No. 2023/CE-II/TK/FencingPolicy

New Delhi, Dated: 23.04.2025

Sub: Policy guidelines for providing safety fencing along the track.

Ref: Board's letter of even no. dated 16.02.2023

TYPICAL DETAIL OF W-BEAM TYPE METAL FENCING	
RE	RE
DIR CE (PLG.)	PRADEEP NAGAR
WR	HIMANSHU SHARMA
XEN-DESIGN-CCG	TANUJ GUPTA
SSE-DESIGN-CCG	SHAKESH SHEDRAH SHETTY
DRG NO. TP BR-95 / 2022-RB

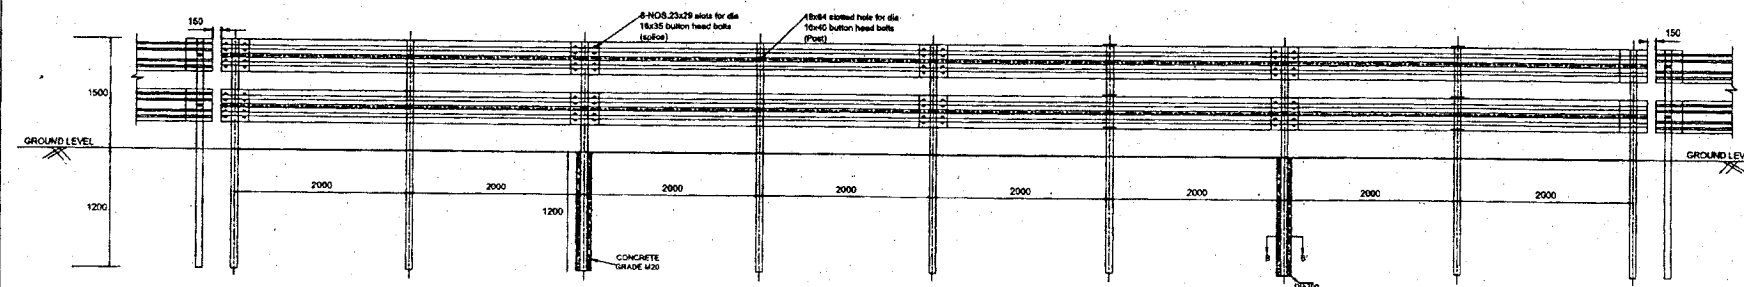
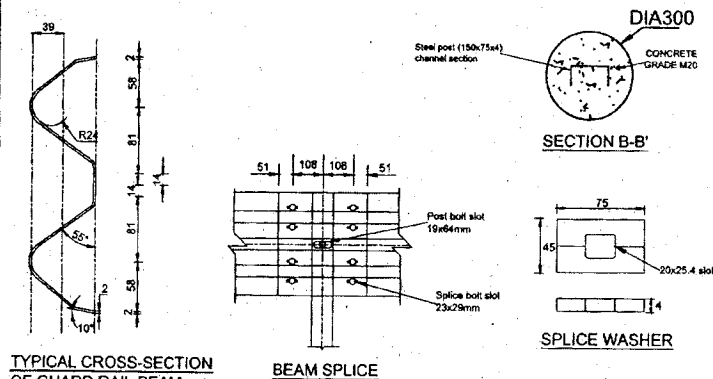
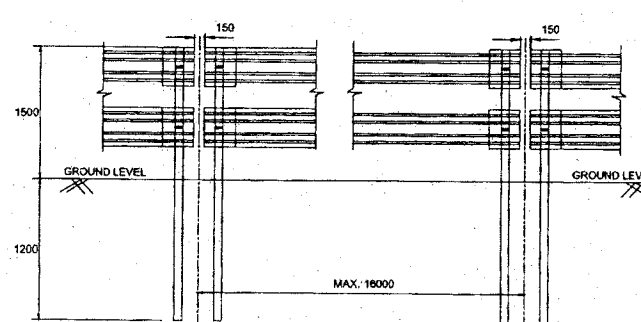
Zonal Railways should select suitable type of fencing such as NHAI crash barrier type design (Schematic diagram of WR) suitably modified and designed or any other fencing based on the requirements of the sections and particular locations. However, it should be ensured that the fencing provided should prevent cattle and vehicle entry on the track.
